Administrative Exception/Variance Request Denial Appeal
City of San Antonio Planning Commission
1901 S. Alamo
San Antonio, TX 78204

RE: **SAT 14 Data Center**
Project #: 21-39801977
UDC Section 35-523
Tree Preservation Variance Denial Appeal

RE: **SAT 14 Data Center**
Project #: 21-39801977
UDC Section 35-523
Environmental Variance Denial Appeal

RE: **SAT 14 Data Center**
Project #: 21-39801977
UDC Section 35-523
Environmental Variance

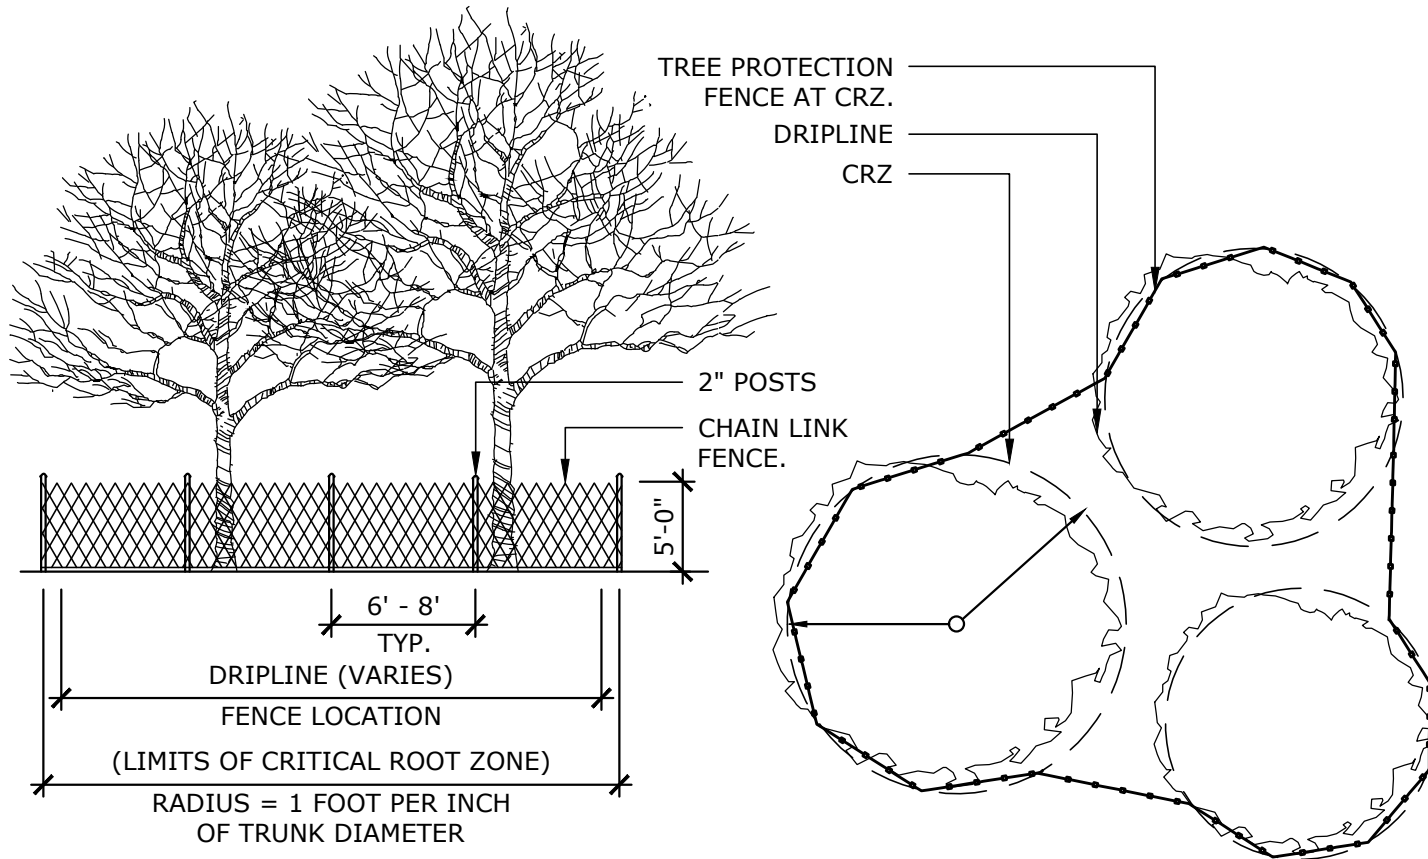
- 4/L1.4- Updated Heritage and Significant tree # and total inches based on recategorizing one 25" heritage tree as one 17" significant tree
- 5/L1.4- Updated mitigation fee required based on the above change
- 6/L1.4- Updated table and summary to reflect change above; revised table summary to remove "inches" from total tree row
- 2-4/L1.8- Updated tables to reflect change above
- 2/L1.11- Updated table summary to reflect change above; revised table summary to remove "inches" from total tree row
- 4/L1.11- Revised table summary to remove "inches" from total tree row
- 1/L1.12- Revised table summary to remove "inches" from total tree row
- 4/L1.13- Revised table summary to remove "inches" from total tree row
- 3/L3.6- Updated Preserved Trees section of Tree Canopy Calculations
